Driver Side Rambox Opens By Itself Unprompted

This bulletin involves removing the driver side Rambox and replacing the Rambox door lock actuator wiring harness with a jumper wiring harness.

2020 - 2021 (DT) RAM 1500 Pickup

**Fig. 2**  
**Rambox Door Lock Actuator Wiring Harness**

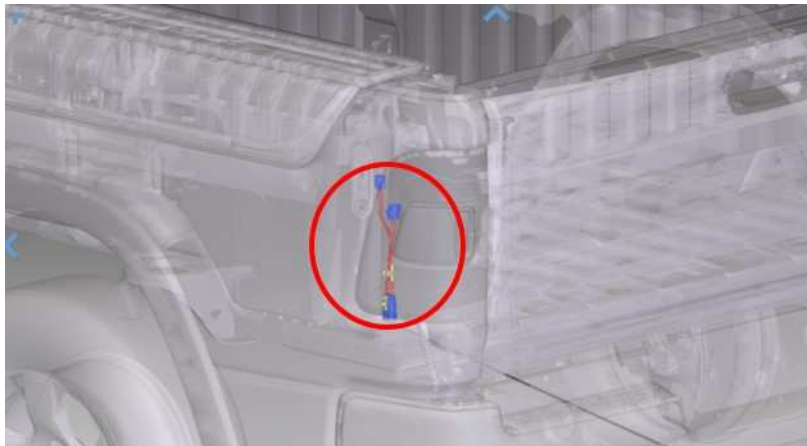
**NOTE:** The above condition is caused by water intrusion ([Fig. 1](#)).

1. Open the driver side Rambox door.
2. Raise and support the vehicle. Refer to the detailed service procedures available in DealerCONNECT> Service Library under: Service Info>04 - Vehicle Quick Reference / Hoisting / Standard Procedure.
3. Disconnect the lower Rambox door lock actuator wiring harness connector.
4. Remove the Rambox. Refer to the detailed service procedures available in DealerCONNECT> Service Library under: Service Info>23 - Body / Exterior / Ram Box / Removal.
5. Replace the Rambox door lock actuator wiring harness with the jumper wiring harness (Fig. 2) .
